## KILDARE COUNTY COUNCIL

### PLANNING DEPARTMENT

<b>Type of Development:</b>	Residential – 30 no. residential units
<b>Part 8 Ref</b>	P82024.15
<b>Site Address</b>	Station Road, Kildare Town. Co. Kildare
<b>Development proposed by</b>	Housing Department
<b>Display period</b>	Advertised in the Leinster Leader on 30 <sup>th</sup> January 2025.  Public display period from 30 <sup>th</sup> January 2025 to 27 <sup>th</sup> February 2025.  Submissions/observations due by 13 <sup>th</sup> March 2025.
<b>Submissions/observations</b>	1 no. submission was received from Prescribed Bodies, 4 no. reports were received from internal departments. 1 no. submission received from a public representative. 5 no. submissions received from members of the Public.

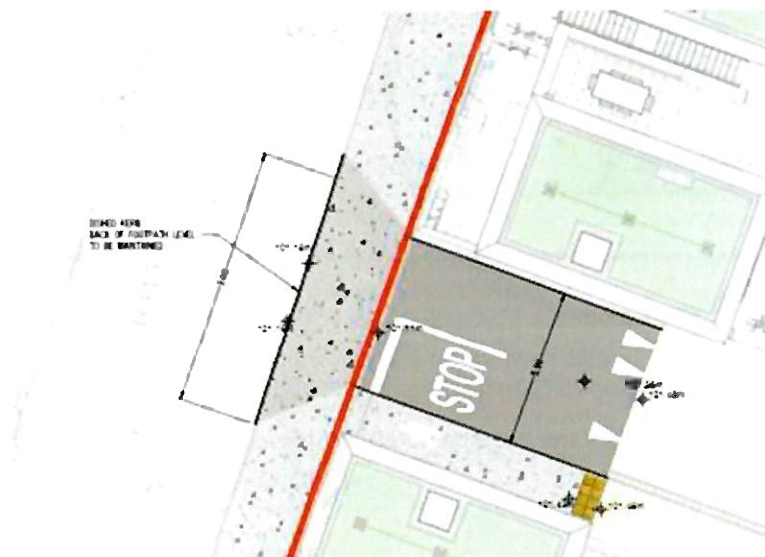
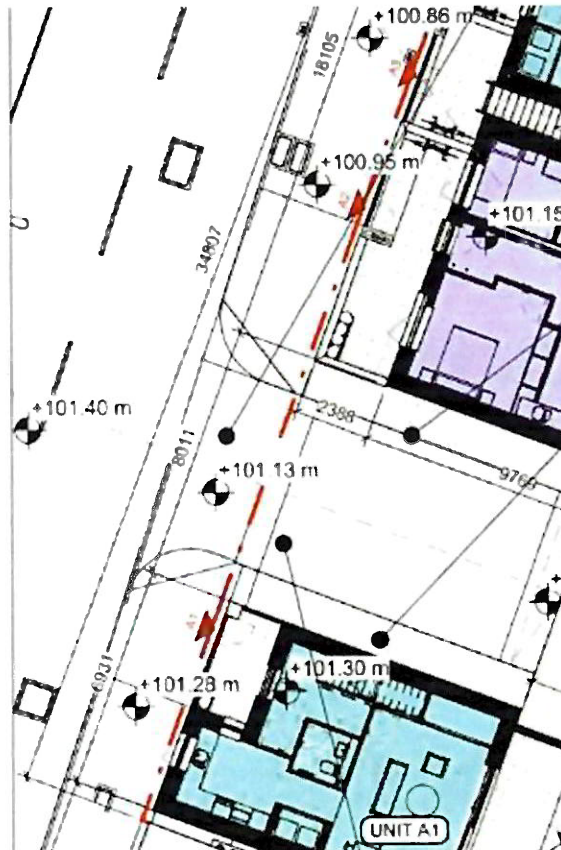
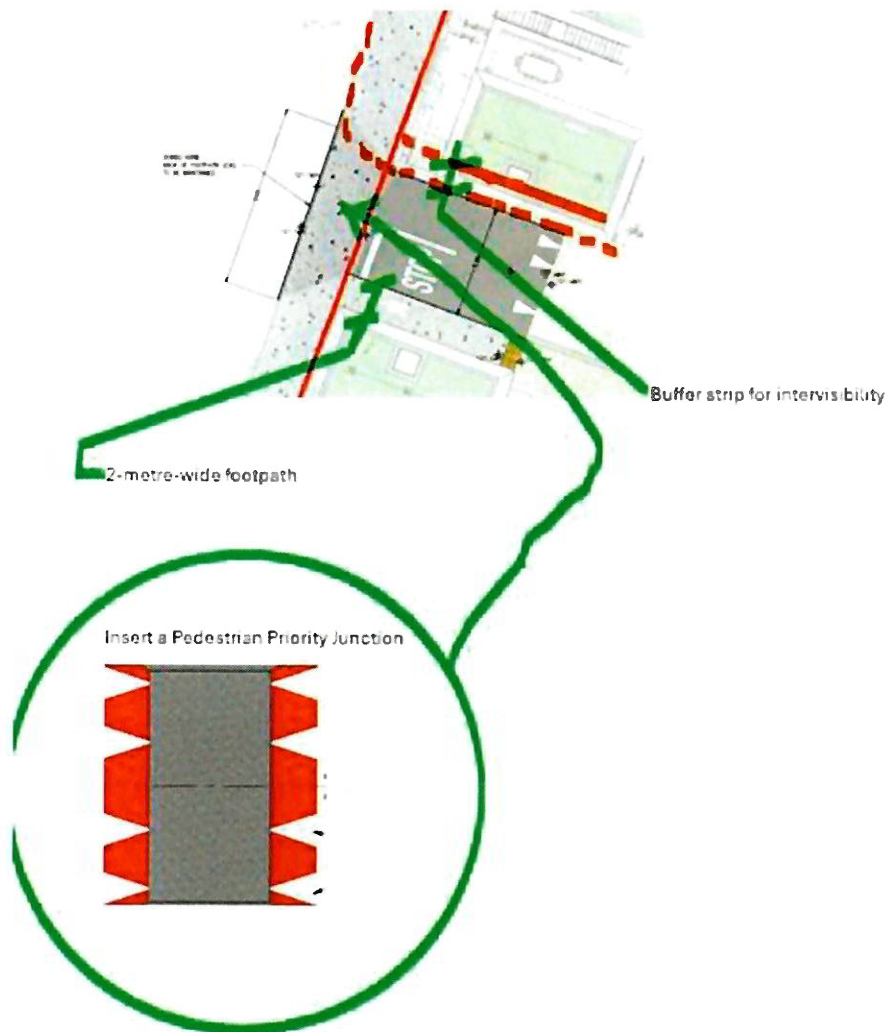
The problem with the proposed solution, following the Road Safety Audit which identified that footpaths were too narrow, was that the intervisibility strip between the boundary wall and the carriageway appears to have been removed on the north side of

the junction to widen the footpath. However, the intervisibility strip is still required at the north side of the junction.

The indented accessible/ disabled parking bays, spaces 1,2 and 3, appear to have their sight lines obstructed by the building on either side, see diagram below for conflict to be resolved.

The visibility splay provided for vehicles exiting the development complies with DMURS requirements, as shown on drawing K114-CSC-ZZ-XX-DR-C-0001.
